SERVICE BULLETIN

Service Bulletin No. / Date: SB TMG 601-1006 P1, Initial Issue / November 05, 2014

Subject: Turbocharger Clamp Replacement

Type affected: All Cessna C172 (Reims F172) with TAE 125-01, TAE 125-02-99 and TAE 125-02-114

Figure 1

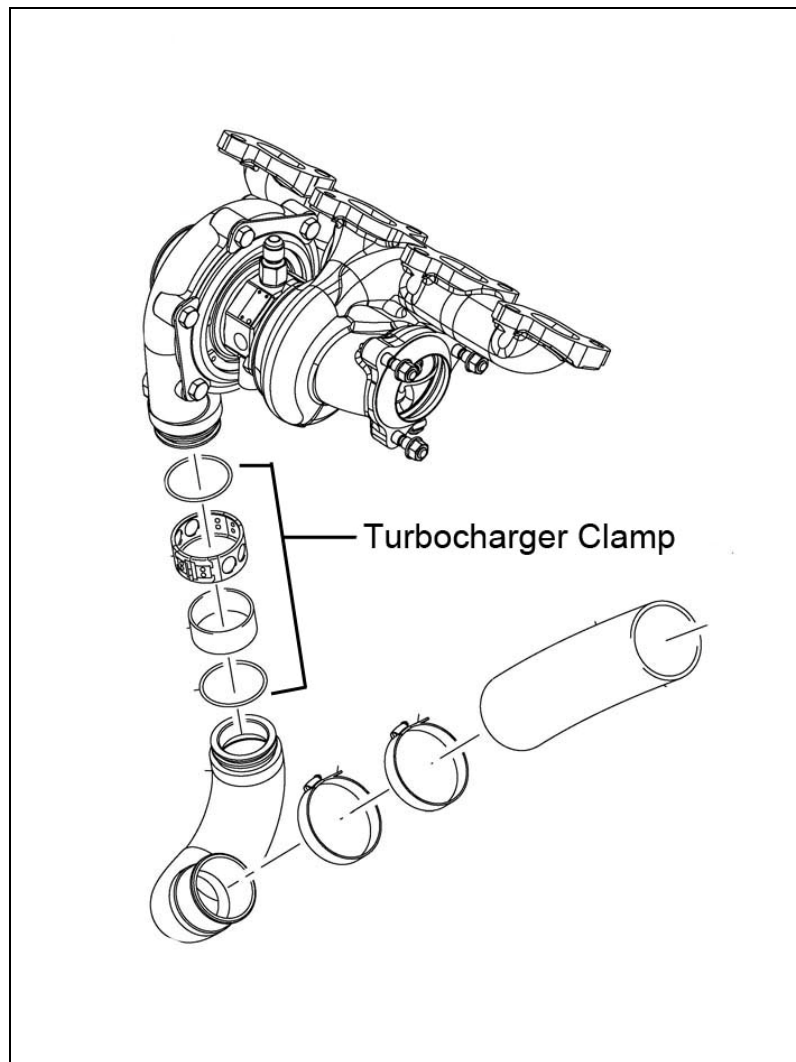
1. Remove the turbocharger clamp:

- Make sure that the engine is cold before starting work at the engine.
- Remove the turbocharger clamp including the inner ring and the O-rings.
- **CAUTION:** When opening the turbocharger system, pay special attention to prevent contamination.

Figure 2

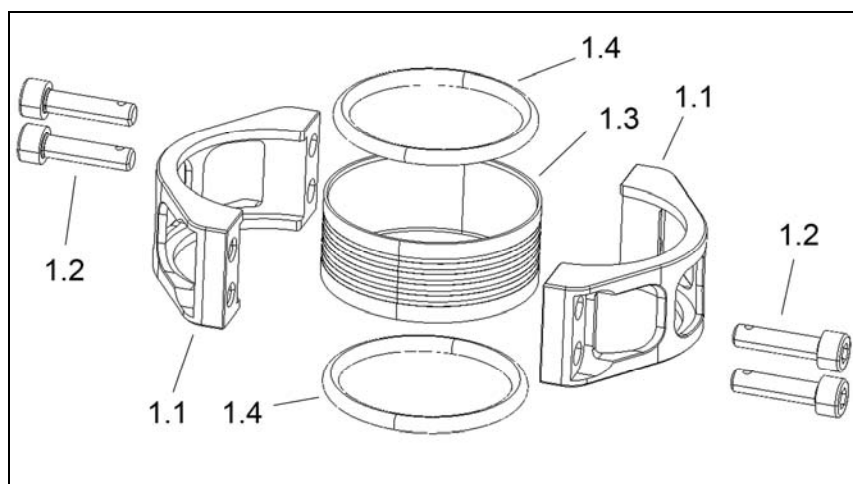
2. Installation of the Turbocharger Clamp (P/N 05-7241-K0216 02)

- Attach one O-ring (item 1.4) to the notch at the flange of the turbocharger.
 - Attach the other O-ring (item 1.4) to the notch at the turbo pipe.
 - ◆ Note: Use lubricant for installation of the O-rings and the coupling. Check correct fit.
 - Connect the turbo pipe to the turbocharger and secure with the coupling (item 1.3) and the two half shells (item 1.1) using four screws (item 1.2). See Figure 2.
- Tightening Torque:** 8Nm
- Check if the clamp can be moved easily.
 - ◆ Note: Tension at the clamp or misalignment of piping can lead to deformation or damage.
 - Secure the screws with safety wire. See Figure 3.
